April 1998

Final
Environmental Impact Statement Amending and Adopting the Draft Environmental Impact Statement - Golden Sunlight Mine

Golden Sunlight Mine Expansion
Jefferson County, Montana

MIXING ZONE

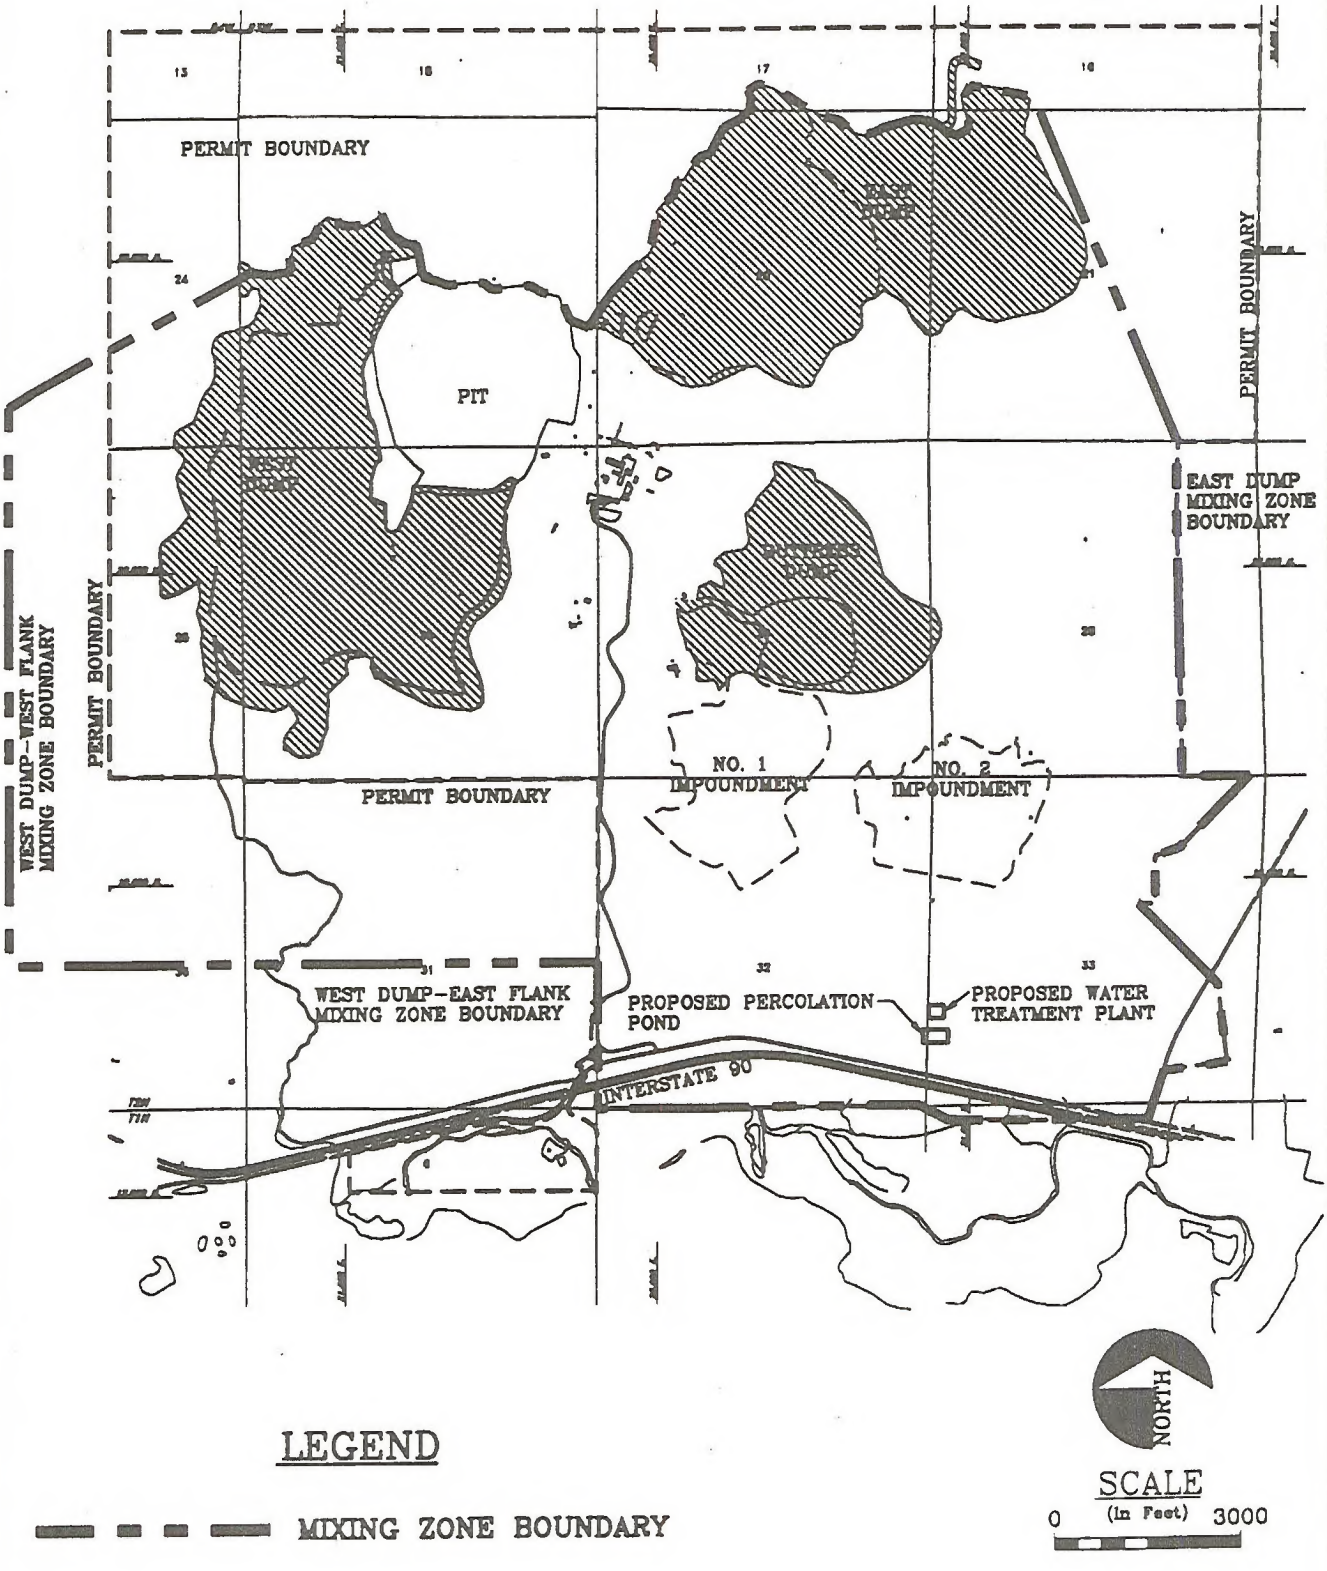
2-44 Figure 5-1. We suggest reconsideration of the proposed mixing zone boundary shown in Figure 5-1 so that the boundary does not extend south of I-90. This would reduce the potential risk of ARD contaminants migrating to and reaching the Jefferson River alluvial aquifer.
